## REPORT OF ALTERATIONS TO DESIGNATED RESOURCE

Site Number/Address: 415 E. Laurel St.

Laurel School National Register Historic District

ISSUED: May 17, 2022

Photos from Applicant

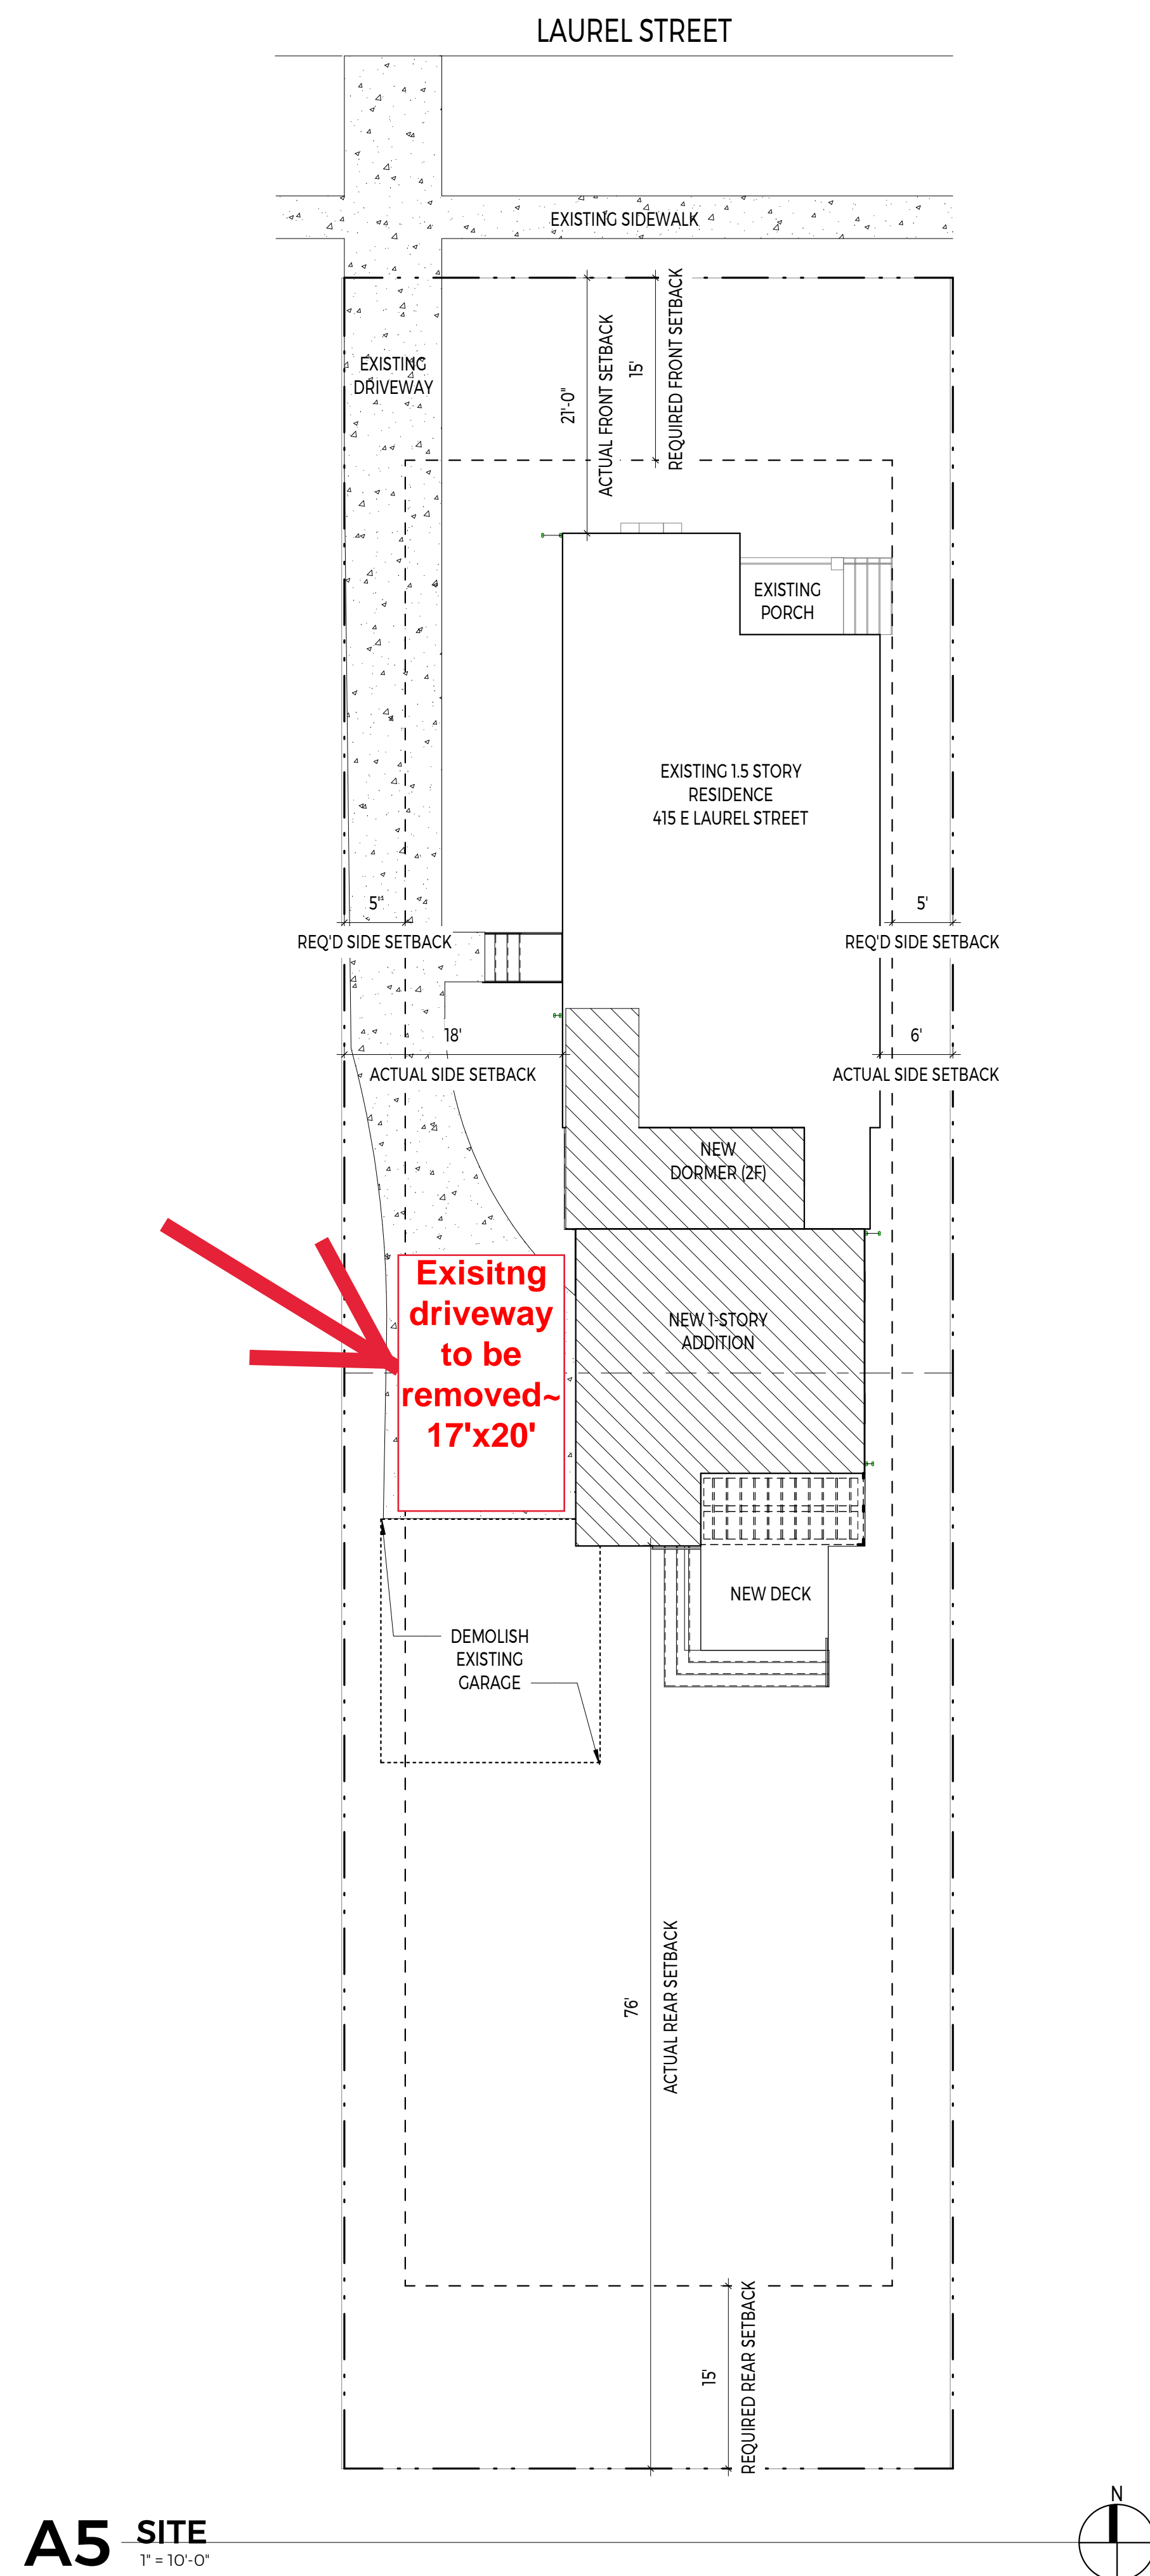
1. Demolition of existing historic garage;
2. Demolition on rear of main house and construction of a 758 ft<sup>2</sup> addition onto the rear (includes both first and second floors)
3. Installation of a rear deck

SOI #3	<p><i>Each property will be recognized as a physical record of its time, place, and use. Changes that create a false sense of historical development, such as adding conjectural features or elements from other historic properties, will not be undertaken.</i></p> <p>The rear addition appears distinguishable enough as new construction based on the siding and glazing choices as to be distinguished as new construction.</p>	Y
SOI #4	<p><i>Changes to a property that have acquired historic significance in their own right will be retained and preserved.</i></p> <p>This Standard is primarily not met because of the demolition of the historic 1934 garage at the southwest corner of the house to accommodate this addition. Absent that significant item, the project otherwise meets this Standard.</p>	N
SOI #5	<p><i>Distinctive materials, features, finishes, and construction techniques or examples of craftsmanship that characterize a property will be preserved.</i></p> <p>While the majority of the project meets this Standard, the key feature being removed that makes this Standard not met is the loss of the historic, 1934 garage.</p>	N

(E) EXTERIOR ELEVATIONS

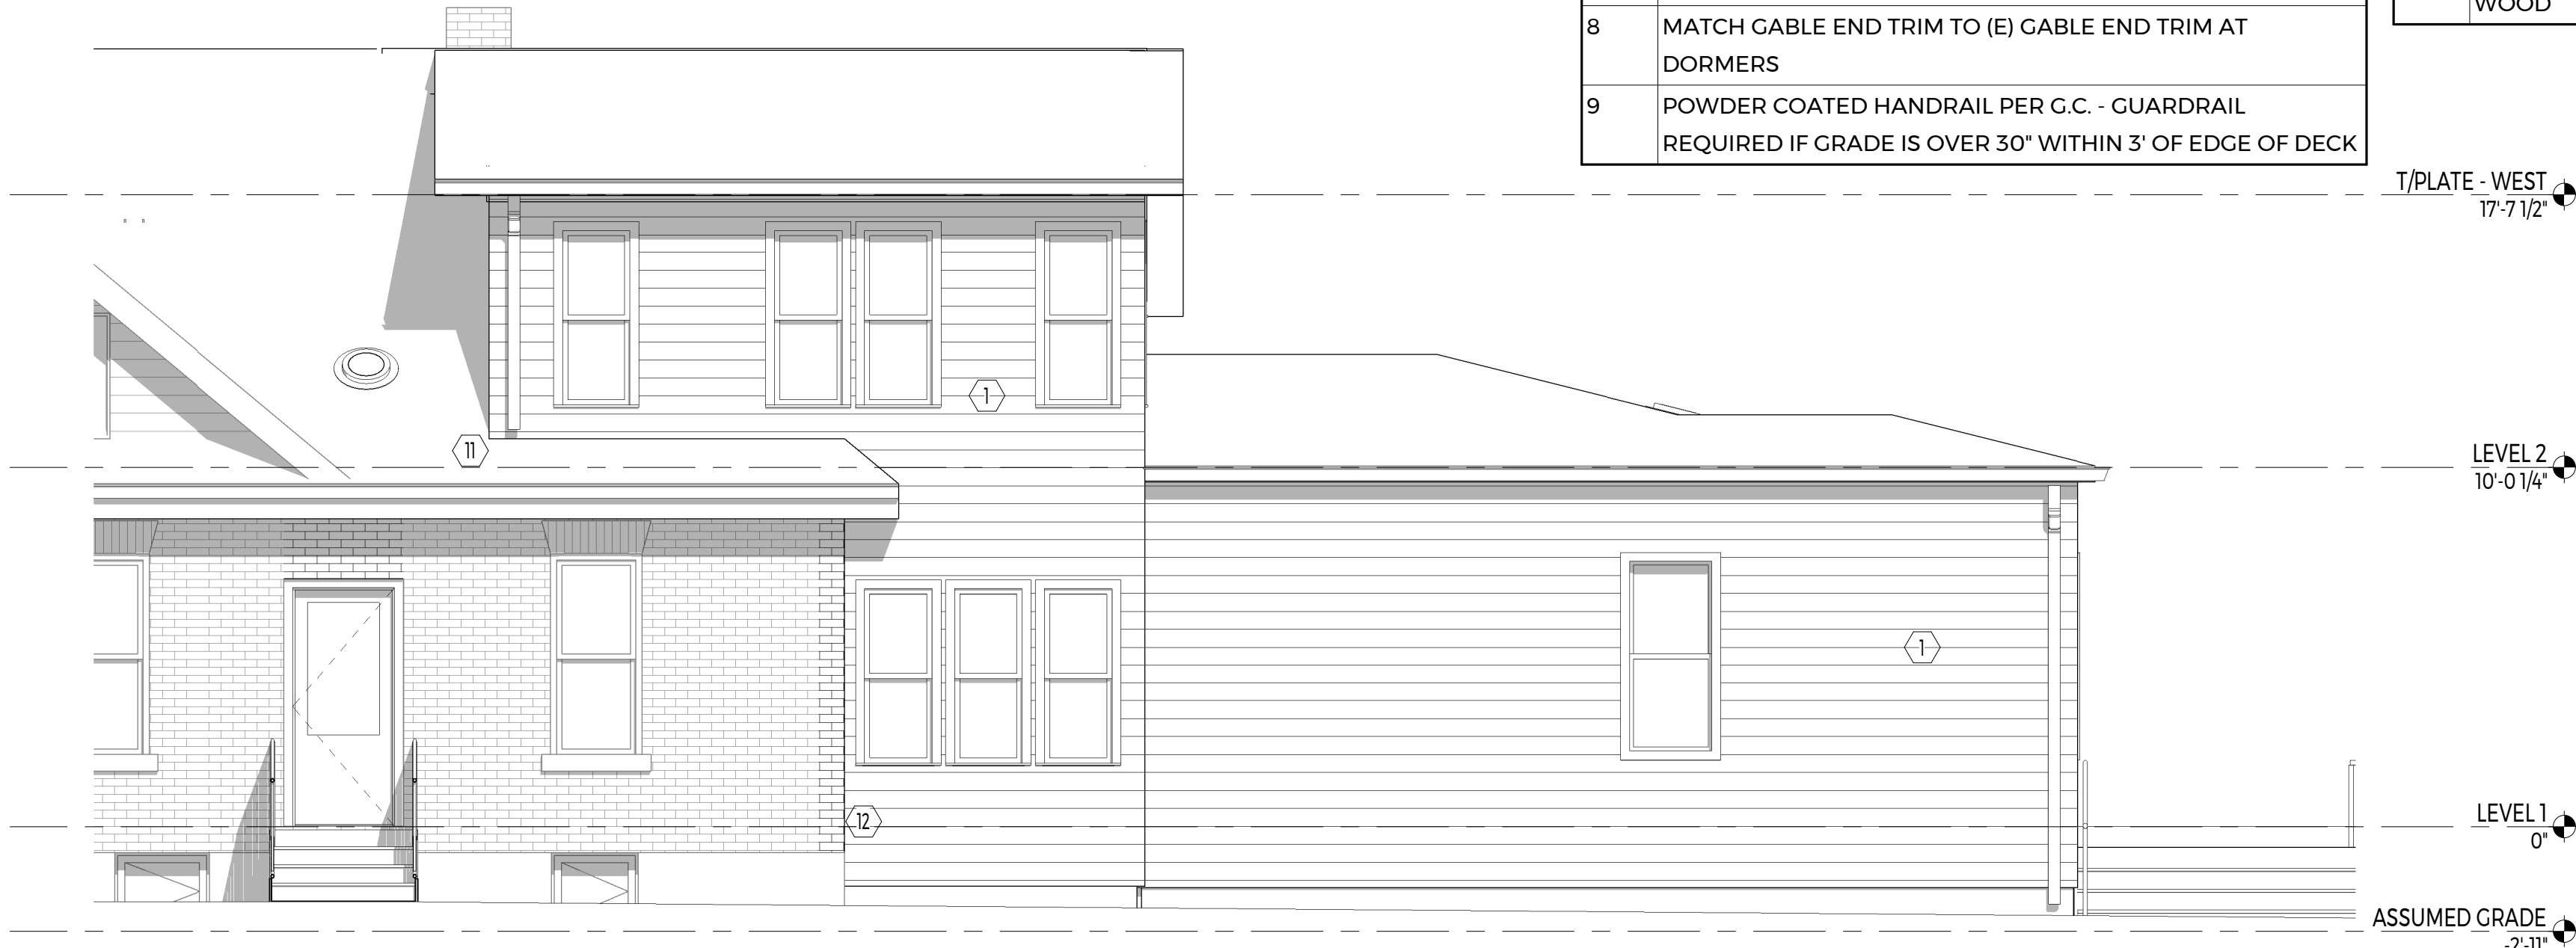
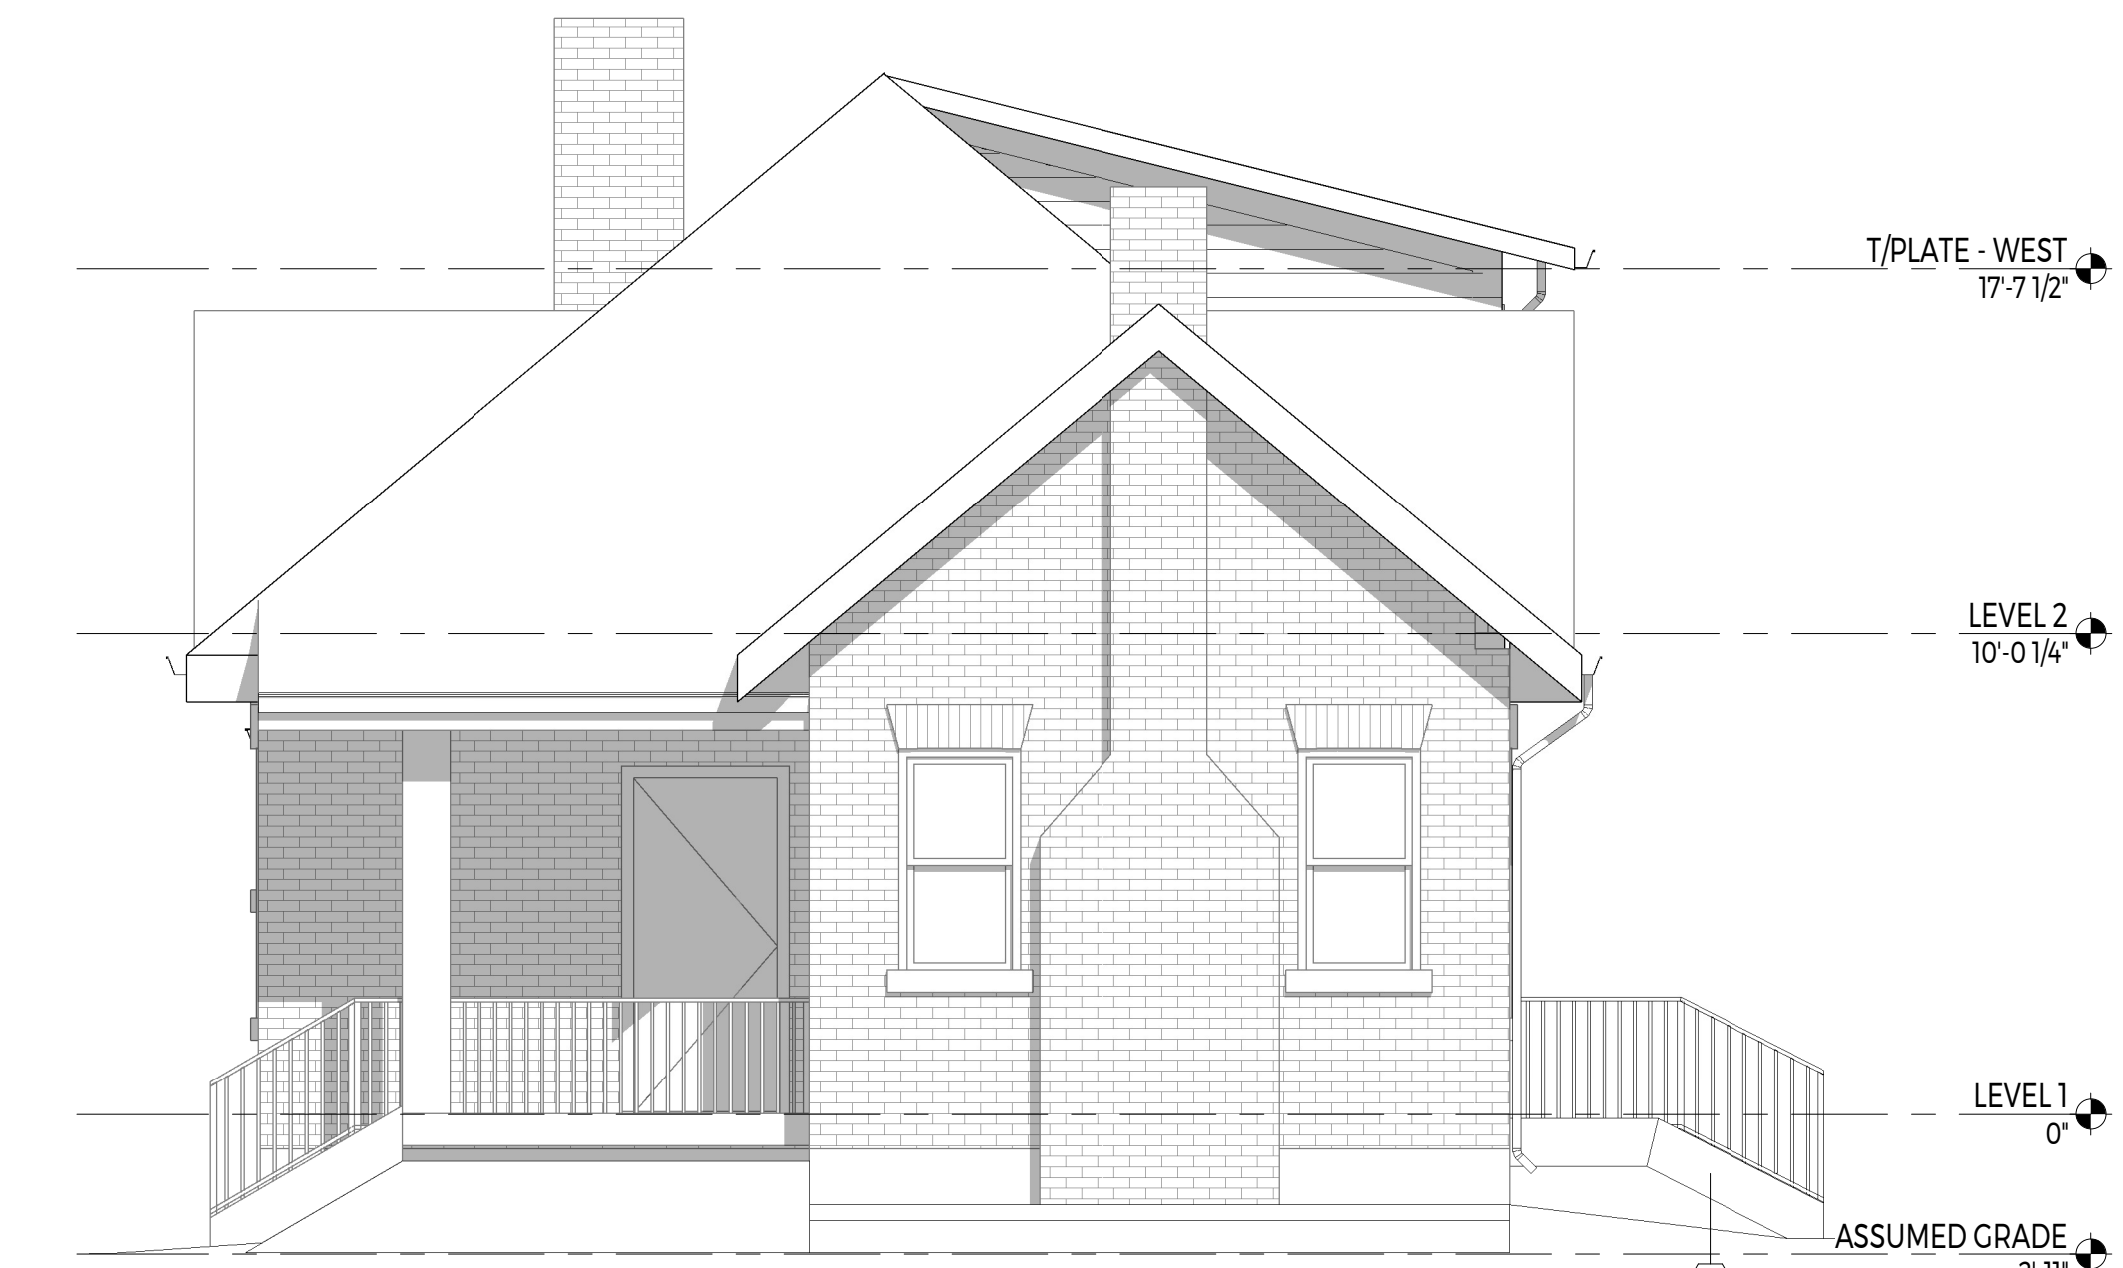
<b>SOI #9</b>	<p><i>New additions, exterior alterations, or related new construction shall not destroy historic materials that characterize the property. The new work shall be differentiated from the old and shall be compatible with the massing, size, scale, and architectural features to protect the historic integrity of the property and its environment.</i></p> <p><b>This Standard calls for additions to be compatible, distinguishable, and subordinate to the historic building. While elements of this project do meet this Standard, overall, this Standard is not met.</b></p> <p><b>The project does not meet the compatibility requirement. While the addition's siding, window pattern, and first floor design generally meet this, the Modern roof form of the second story addition, and the demolition of the historic garage to accommodate the addition do not meet this aspect of this Standard.</b></p> <p><b>The project does meet the distinguishability requirement. The use of similar window patterning in the addition that incorporates both historic and modern window designs, and selection of wide lapboard siding, help the new building be distinguished from the historic.</b></p> <p><b>The project does not meet the subordination requirement. While it does well in attaching to the rear of the historic house, and generally being smaller in footprint than the historic house, it</b></p>	<b>N</b>

<b>will be noticeable and visible from Laurel Street since the west dormer elevation rises above the historic gable dormer on that elevation.</b>	
<b>SOI #10</b>	<p><i>New additions and adjacent or related new construction will be undertaken in such a manner that, if removed in the future, the essential form and integrity of the historic property and its environment would be unimpaired.</i></p> <p><b>While the addition to the house generally meets this Standard, the loss of the historic garage to accommodate the addition footprint is the primary reason this Standard is not met.</b></p>	<b>N</b>
